LETTER AND RESPONSE TO REGULATOR COMMENTS ON FOURTH FIVE-YEAR REVIEW  
REPORT NIROP FRIDLEY MN (PUBLIC DOCUMENT)  
9/27/2013  
TETRA TECH

Subject: Responses to Comments - Fourth Five-Year Review Report  
NIROP Fridley, Fridley, Minnesota

**RESPONSES TO EPA COMMENTS ON THE FOURTH FIVE-YEAR REVIEW  
REPORT  
DATED MAY 2013**

**NAVAL INDUSTRIAL RESERVE ORDNANCE PLANT  
FRIDLEY, MINNESOTA**

**Legend**

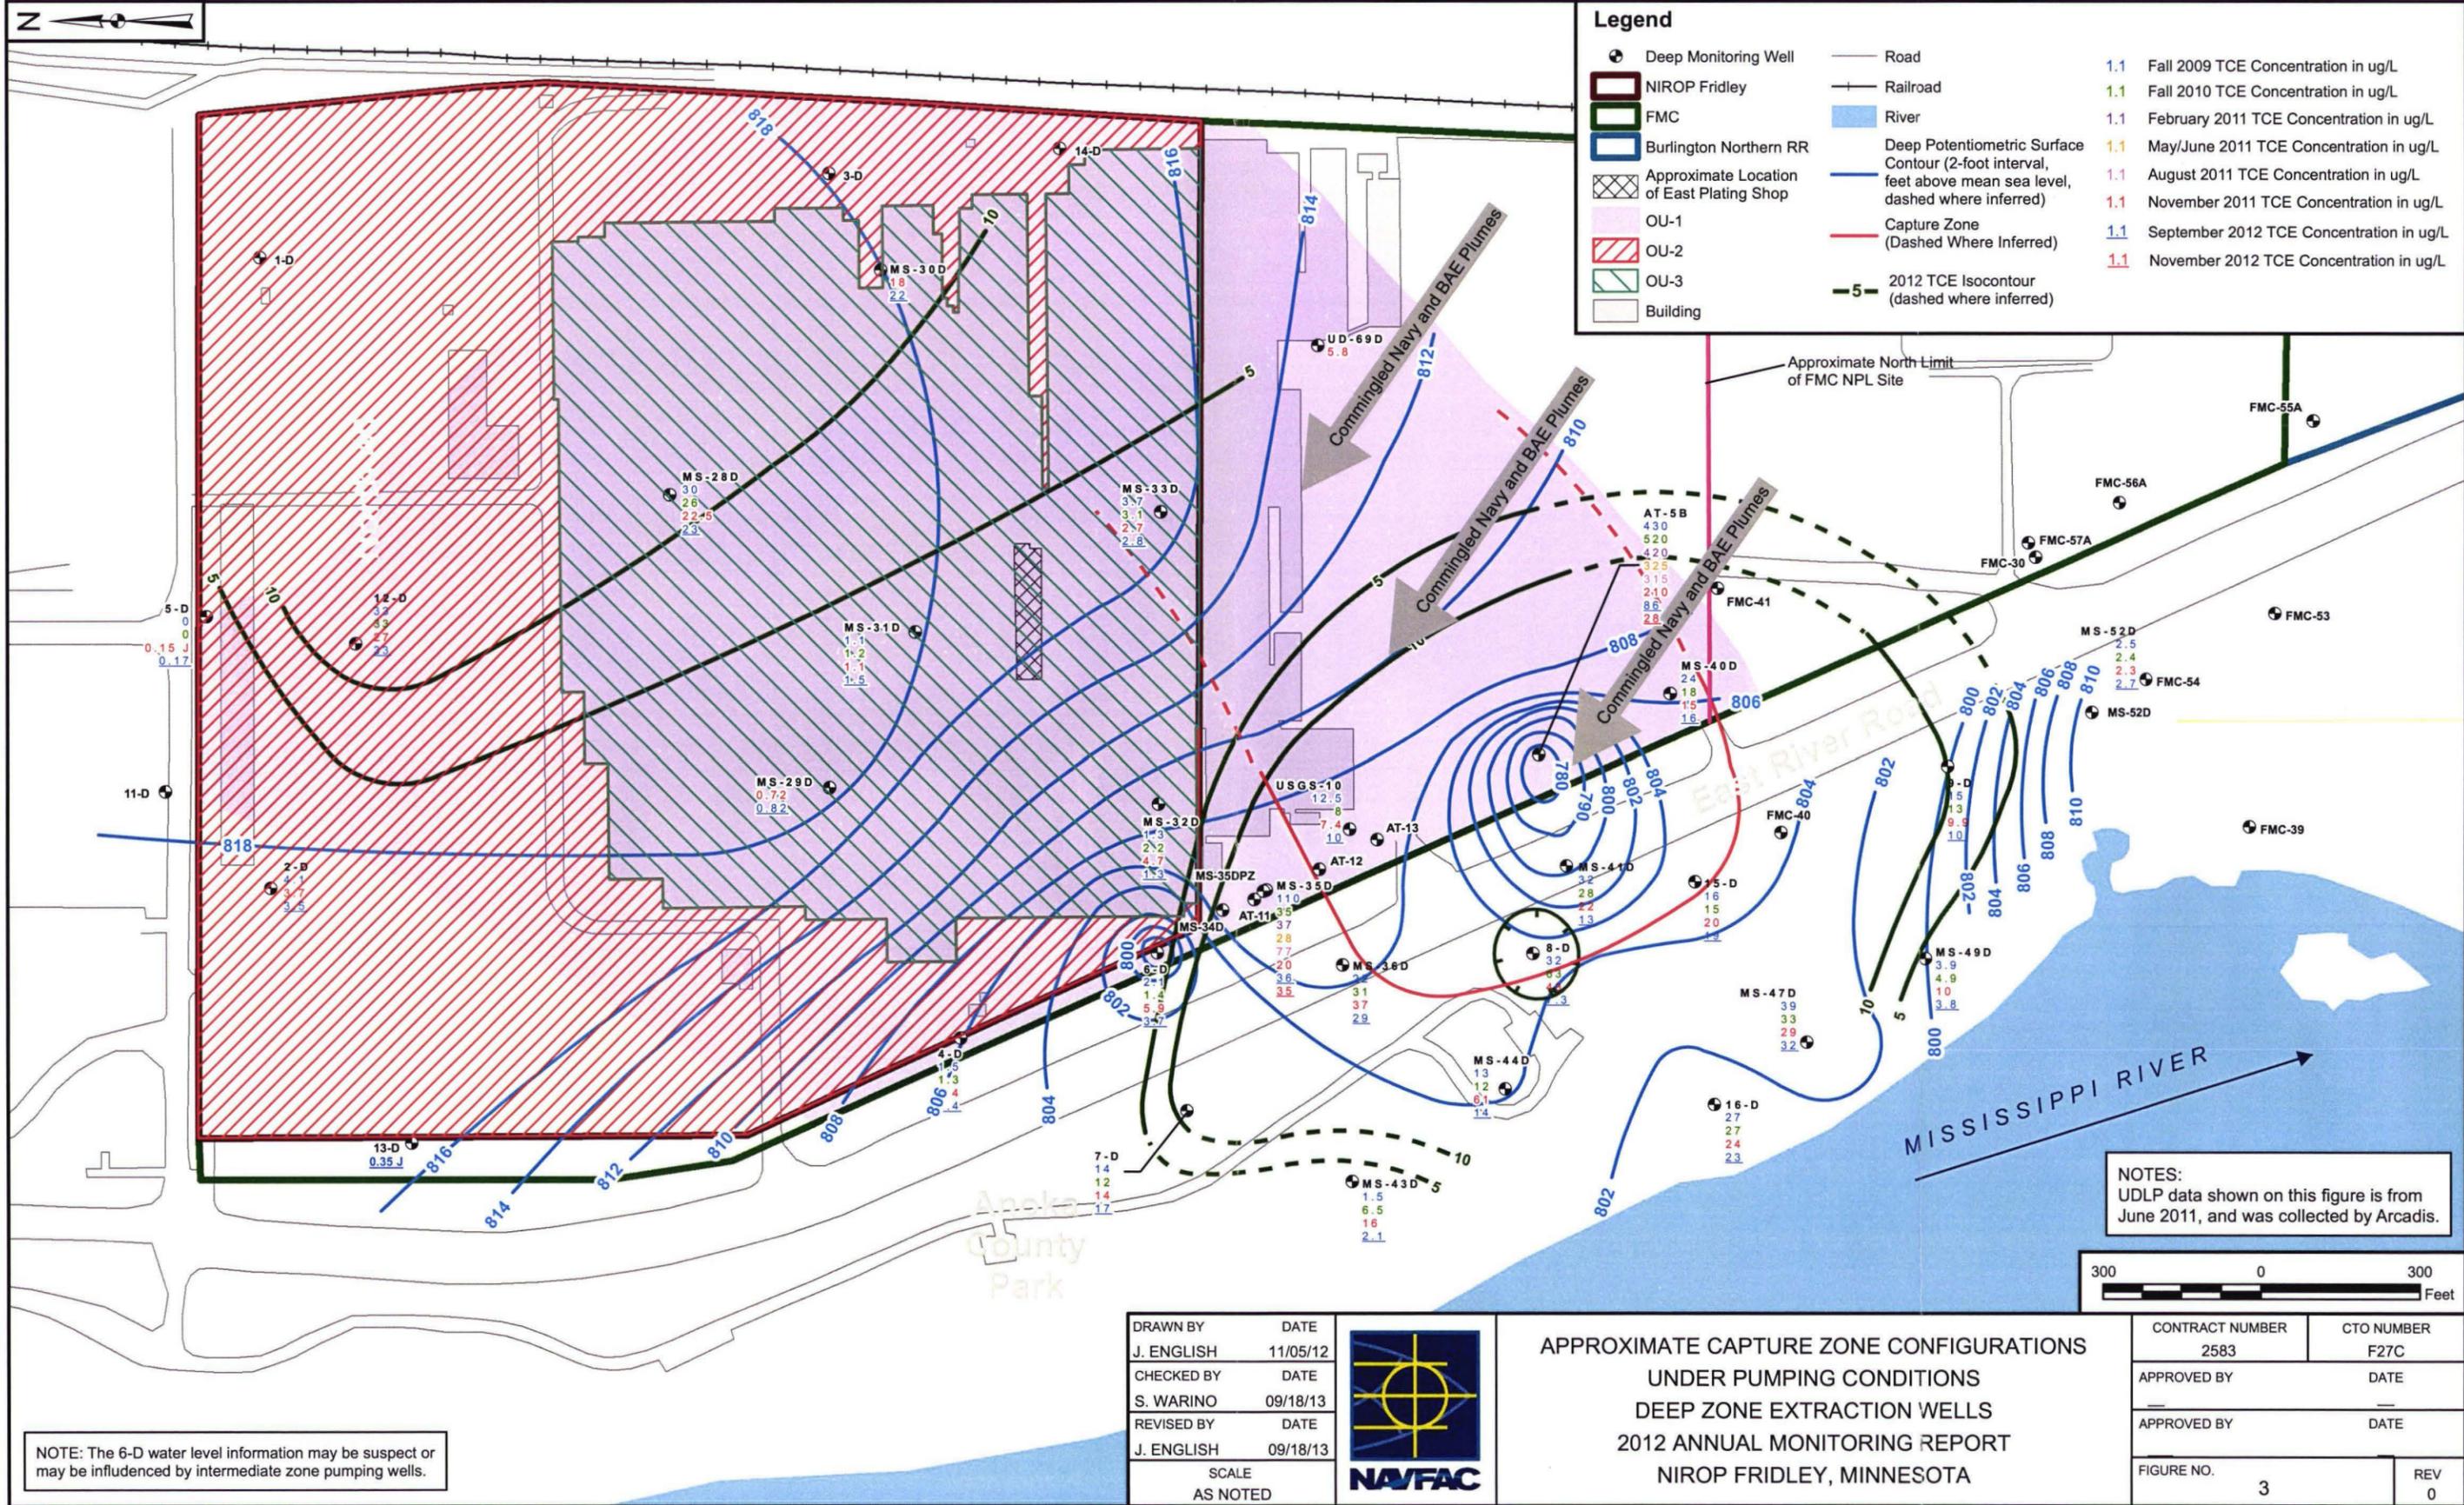
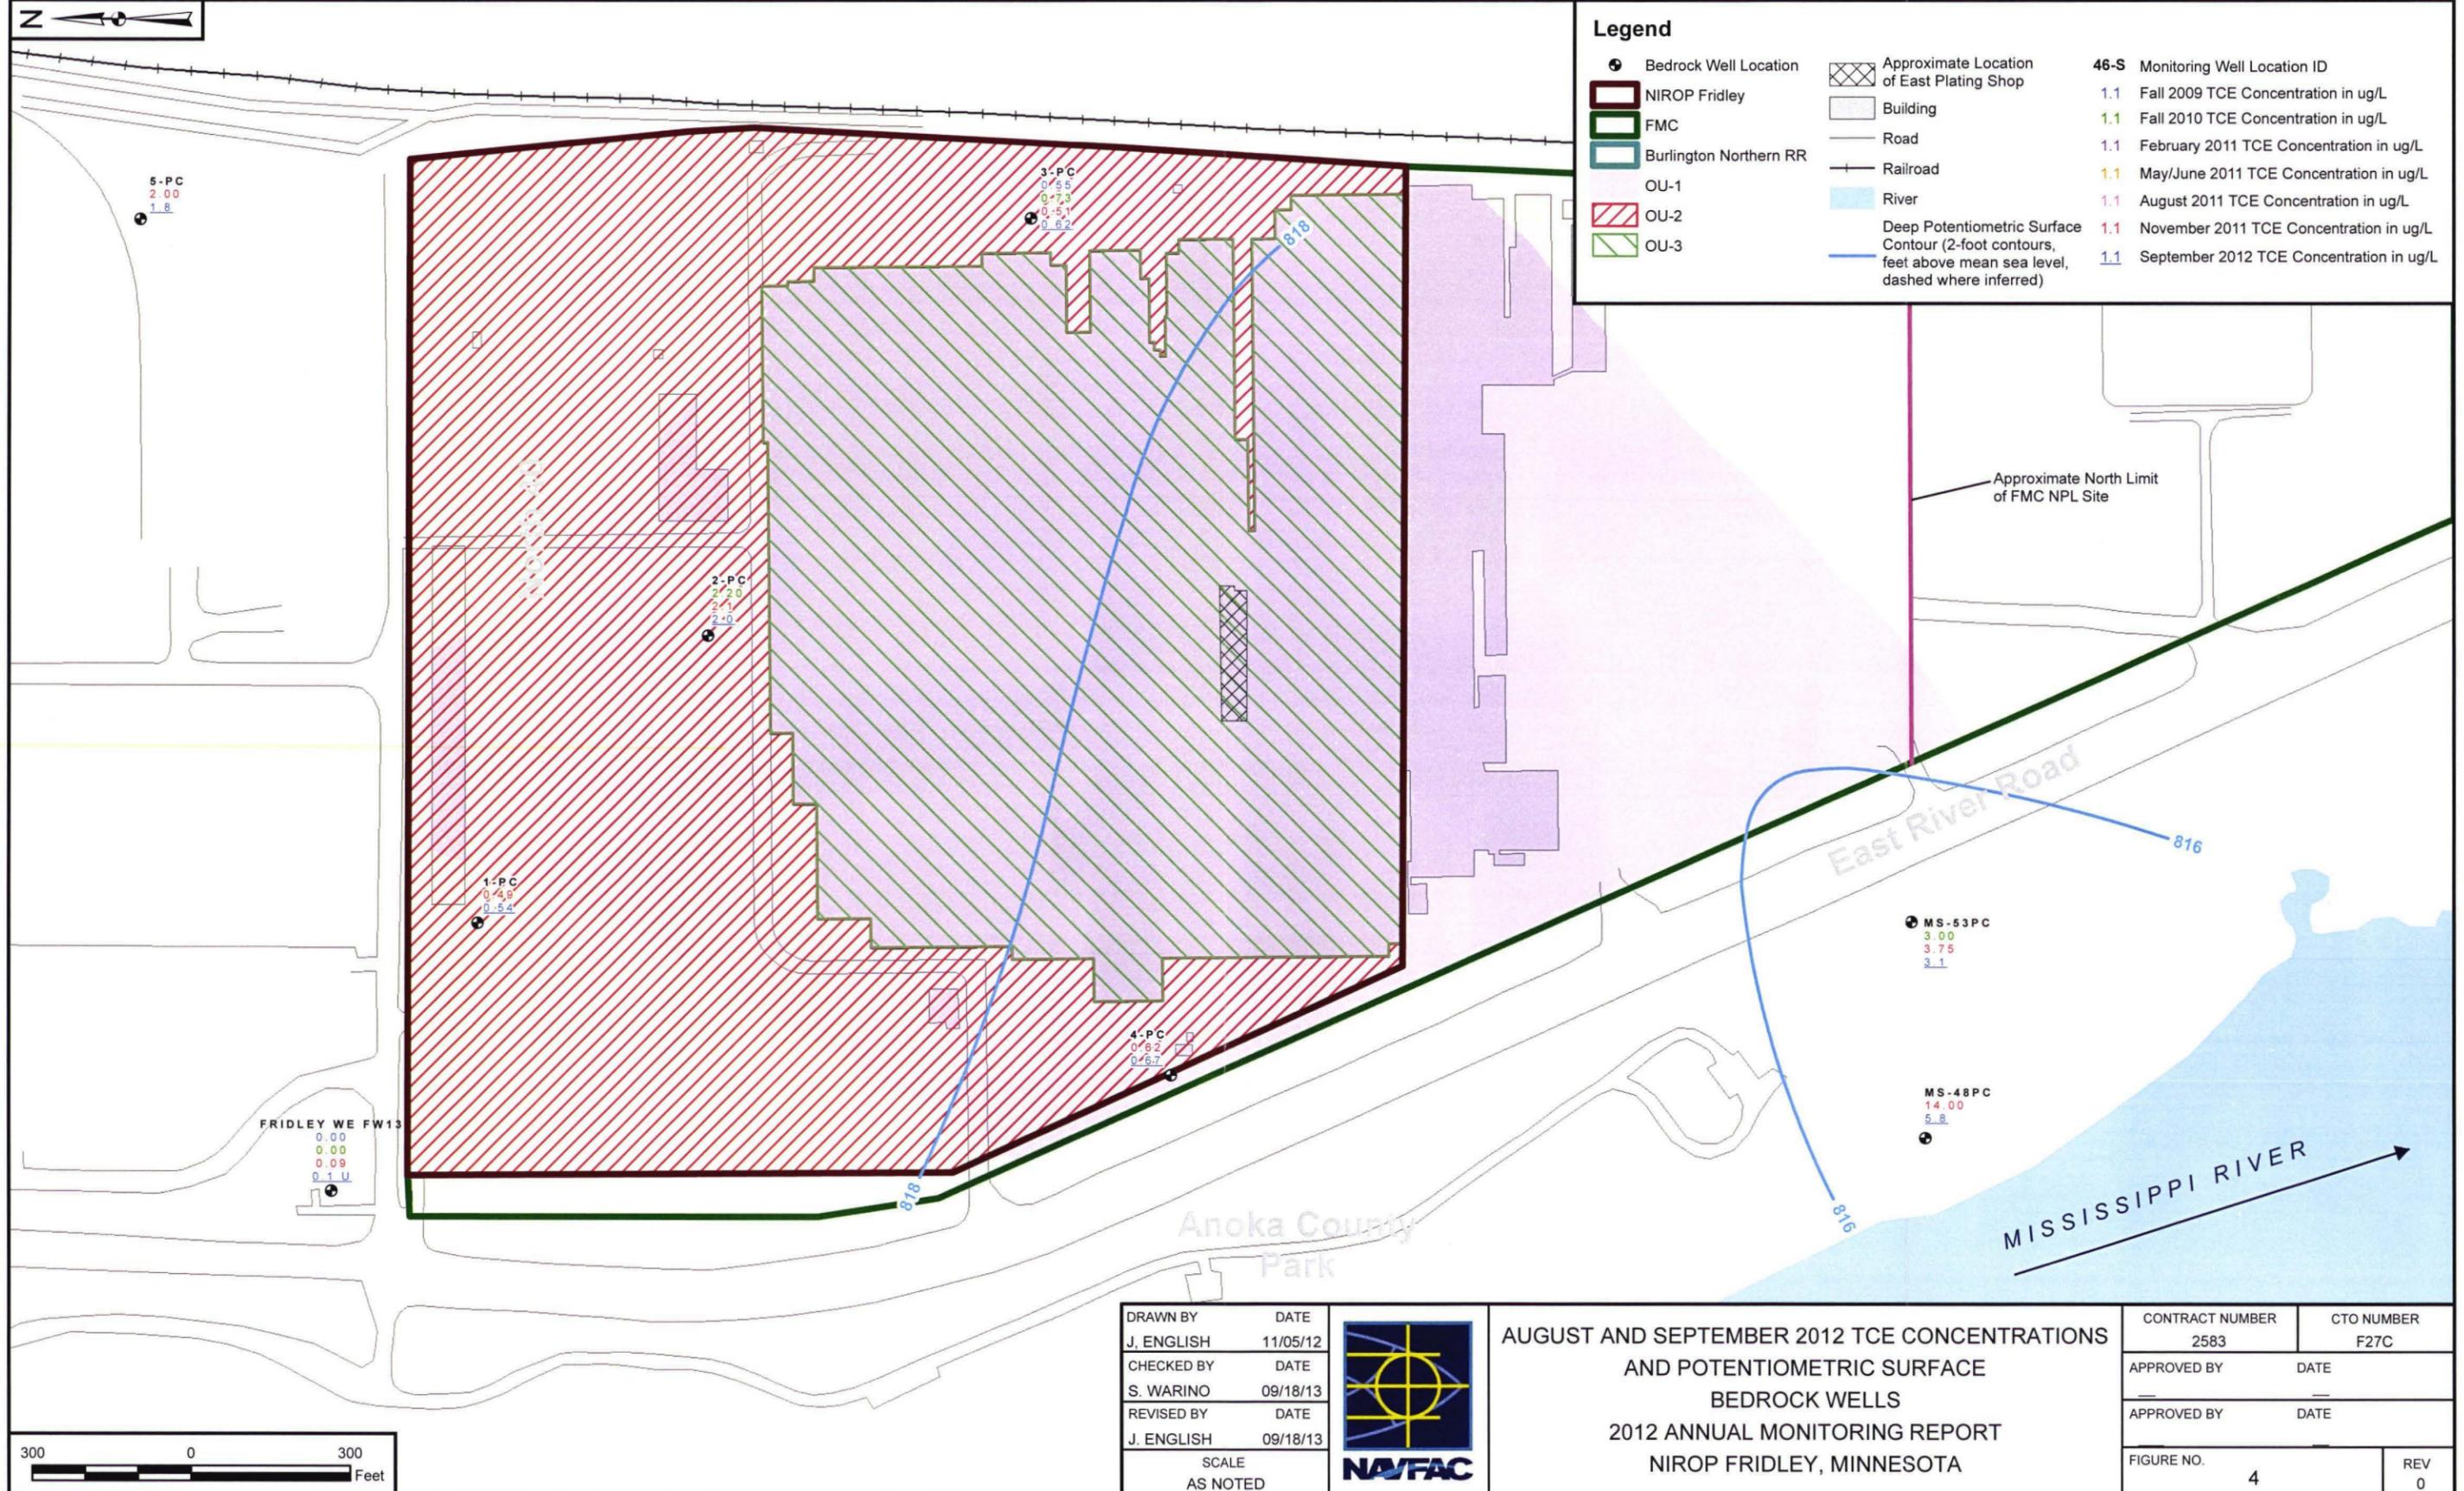
**12. Comment: Section 7.2.5.1, Problem B: Effectiveness of the Capture Well System, Page 7 of 9:** The last sentence of Section 7.2.5.1 references Attachment 3 as support that the system continues to show significant improved performance; however, Attachment 3 (TCE Isoconcentration Maps and Approximate Capture Zone Configurations) includes TCE isoconcentration maps and the approximate capture zone configurations. These do not show significant improved performance of the system. Revise Section 7.2.5.1 to reference figures and tables which support that the system continues to show significant improved performance.

**Response:** The following text has been added just before the reference to Attachment 3: “and effectiveness in capturing contaminated groundwater”. The figures are meant to show substantial capture of contaminated groundwater.
